Shell Canada Limited

**Applications for an Oil Sands Mine, Bitumen Extraction Plant,
Cogeneration Plant, and Water Pipeline in the
Fort McMurray Area**

February 5, 2004

**REPORT OF THE JOINT REVIEW PANEL ESTABLISHED BY THE
ALBERTA ENERGY AND UTILITIES BOARD AND THE GOVERNMENT OF CANADA**
Decision 2004-009: Shell Canada Limited, Applications for an Oil Sands Mine, Bitumen
Extraction Plant, Cogeneration Plant, and Water Pipeline in the Fort McMurray Area
February 5, 2004

Figure 1. Shell Jackpine Mine and surrounding area

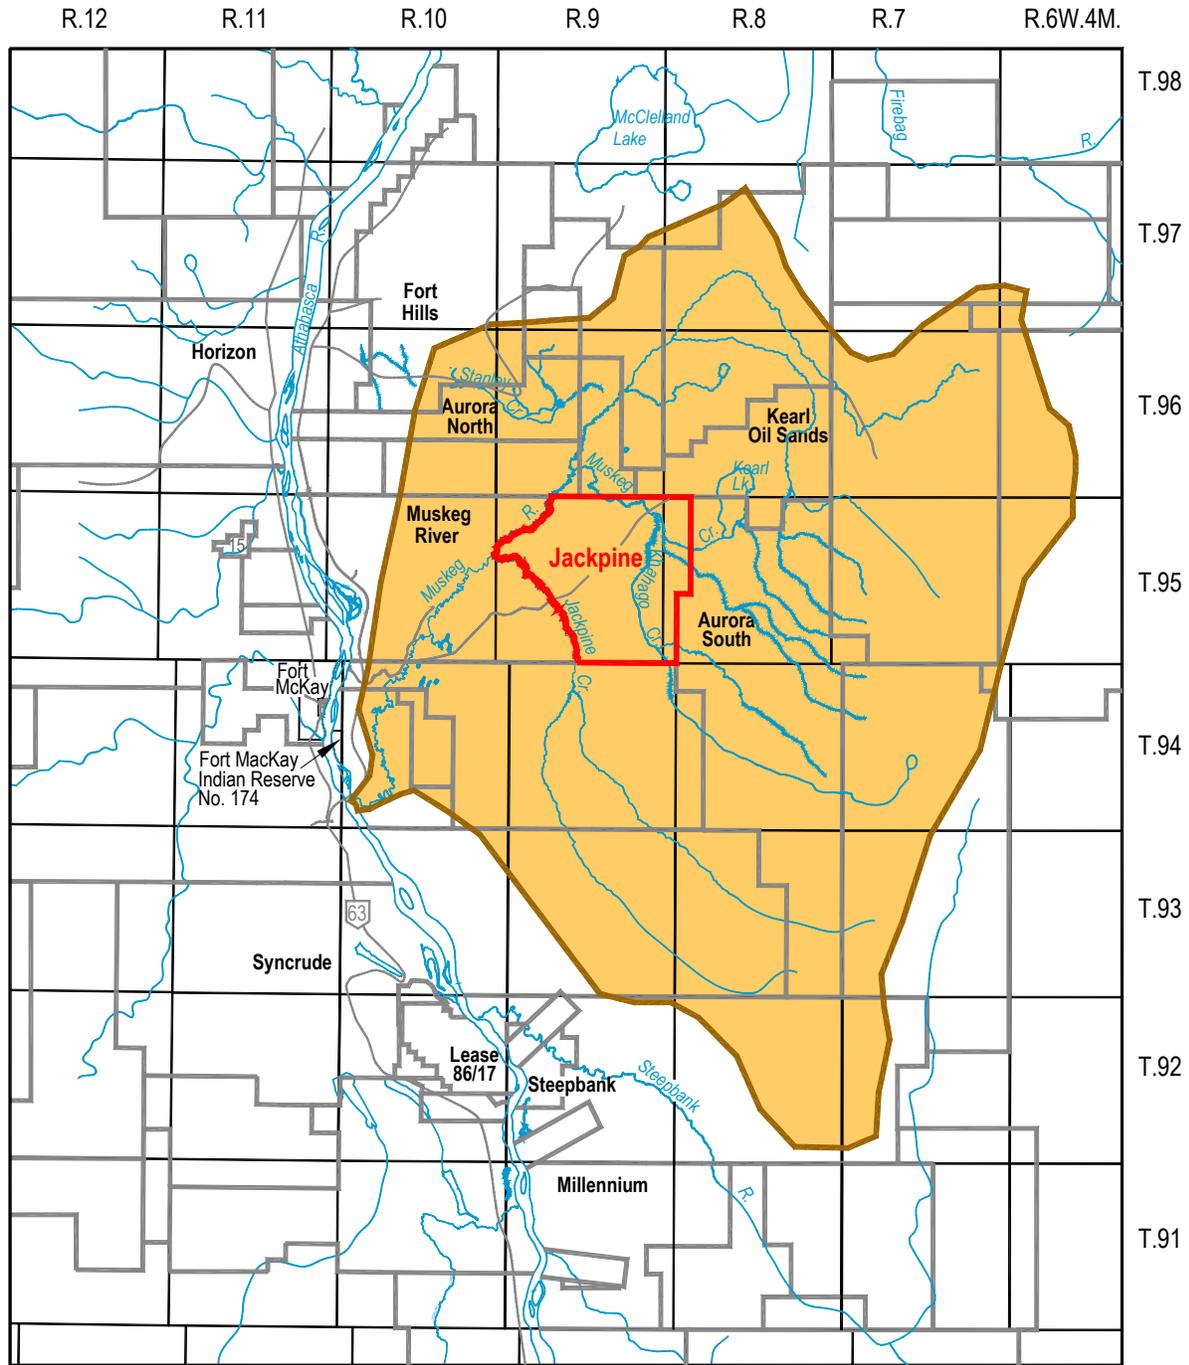
A marginal pit expansion area, denoted as SH02-537, would encroach on the plant site footprint. Shell's evaluation indicated that area was not economic to mine (Figure 1). However, Shell stated that it would complete additional resource drilling along the pit limits in the area prior to finalizing the footprint limit of the plant site.

Shell identified a marginal mining area, denoted as area DH-141, which encroached on the northwest corner of the tailings disposal area, but stated that this area was not economical to mine. Shell stated that while it did not provide the results of combining area DH-141 and SH02-537, work that was completed resulted in a higher combined TV:BIP value than that of either of these pit extensions on their own. SH02-537 was a marginal zone that encroached on the plant site. Shell said that it would complete drilling along the pit limit near the plant site and tailings disposal area prior to finalizing the footprint of either of the sites (Figure 1).

The Panel believes that the plant site footprint is sufficient for the proposed project. However, the Panel will require Shell to obtain EUB approval should the plant site area need to be larger. The Panel directs Shell to submit, for EUB approval, a resource assessment of the plant site area two years prior to construction.
